# Technical Service Bulletin

<b>Subject:</b>  FUEL-FILLER LID PANEL IS DEFORMED	<b>Bulletin No.:</b> 09-007/25
	<b>Last Issued :</b> 01/29/2025

2020-2025 CX-30  
2019-2025 Mazda3

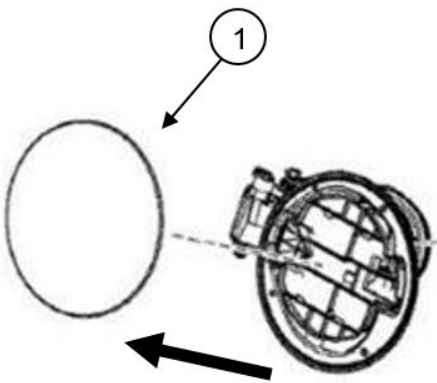
Some vehicles may exhibit a deformed fuel-filler lid panel (1) attached to the fuel-filler lid box, resulting in a poor appearance.

This concern is caused by the lid box not having enough water drainage capability which leads to the accumulation of water inside it. The water then freezes in cold weather and expands or the inner side of the lid panel absorbs the water and swells from long exposure, deforming the lid panel. To eliminate this concern, the shape of the fuel-filler lid box has been modified to have better drainage capability and a modified fuel-filler lid panel service part has been established for less water absorbance.

2. Replace the fuel-filler lid panel (1) with a modified one according to the instructions on MGSS.

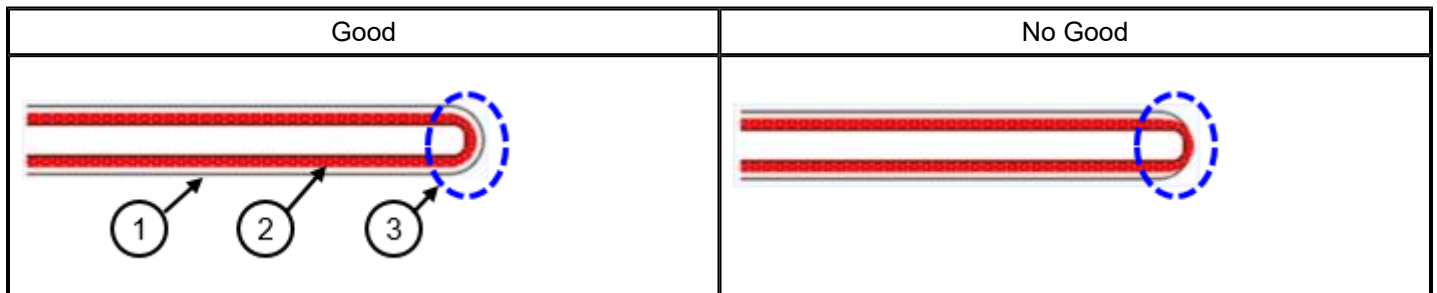
- It is not necessary to remove primer on fuel filler lid before refinish painting.
- Apply clear paint (1) enough to cover the base paint (2) at the edge (3) of the fuel-filler lid panel.
- Avoid excess paint at the edge (3)
